## Finding of No Significant Impact (FONSI)

## **Environmental Assessment**

For the Miles City Street Projects:

## **Finding of No Significant Impact**

**Figure 3. Miles City Street Network**

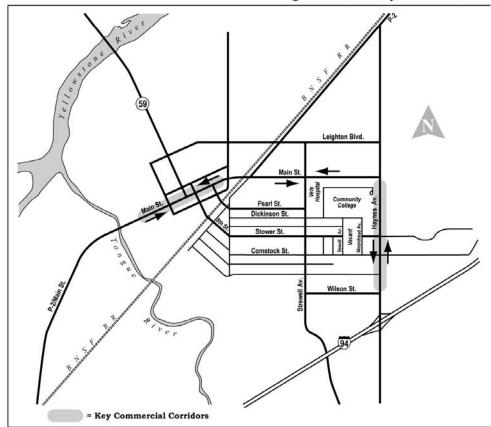
3.0 Impacts. 3.1 EFFECTS ON THE TRANSPORTATION SYSTEM. Access and Traffic. Access. (Page 17) Figure 3 contains some omissions, the inclusion of which might affect the analysis of the situation. Specifically, although it shows the college and the VA (both of which are closer to Main than to Stower), it fails to include Highland Park School and Wibaux Park. In addition. it does not include the railroad crossing on Fourth. This crossing might provide a better "balance" for the routing of traffic since it provides a greater distance between available routes. inclusion of the Leighton Blvd. crossing in the current proposals for possible railway grade separation locations (over or underpasses) has also not been mentioned. The selection of this site would be anticipated to affect traffic patterns. In addition, it should be noted that, although Eighth has been indicated as a planned site for an over or underpass (December 15, 1988 City County Planning Board minutes, March 2002 letter from George Luther, and John Mark's January 8, 1999 letter), this crossing was not a "finalist" in the MDT railway grade separation analysis. In other words, there are a multitude of alternatives that do not seem to have been fully evaluated for the routing of traffic. Surely it is possible to find one that avoids routing large amounts of traffic through a residential neighborhood.

Figure 4. Community and Environmental Resources

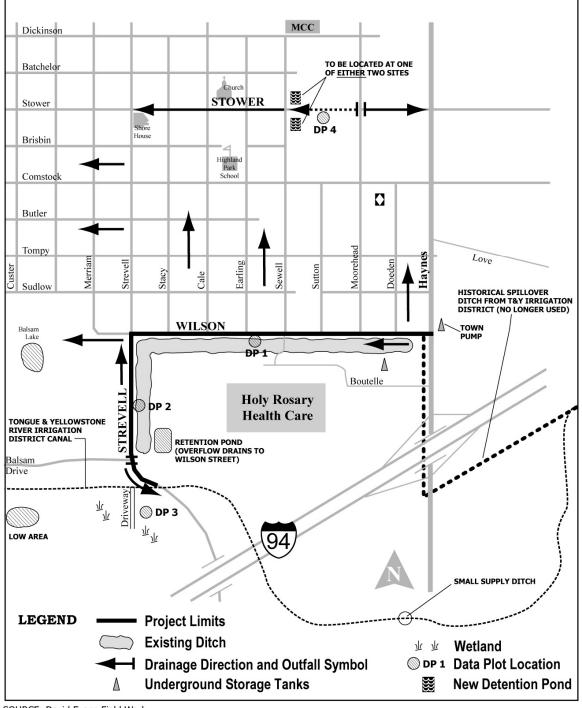
Schools. (Page 21) Figure 4. Community and Environmental Resources. This figure fails to indicate that Sewell from Batchelor to Comstock is a one way street--an important issue in the analysis for the traffic flows and impacts.

Unfortunately, the drafters of the above statements and figure 4 (map) failed to do a full survey of the area. No one seemed to notice that Sewell is a one way street from Batchelor to Comstock going away from MCC. The completion of the project on Stower will not to improve access to MCC. Stower and Dickinson are parallel streets. The traffic would still have to go to Dickinson to access the college either via Moorehead or Cale/Winchester (since Sewell is a one-way street from Batchelor going in the opposite direction). Perhaps a better alternative for the college is a route off of Main (which is closer and could also serve the VA via This route would also avoid Dickinson (minimizing the rear). traffic) for those individuals parking in the first parking lot. Access to MCC remains the same whether the Stower project is completed or not. If additional road projects such as Sewell are planned, these should have been included in the Environmental Assessment.

Figure 4 was intended to illustrate the main activity sites in the vicinity of the proposed projects.
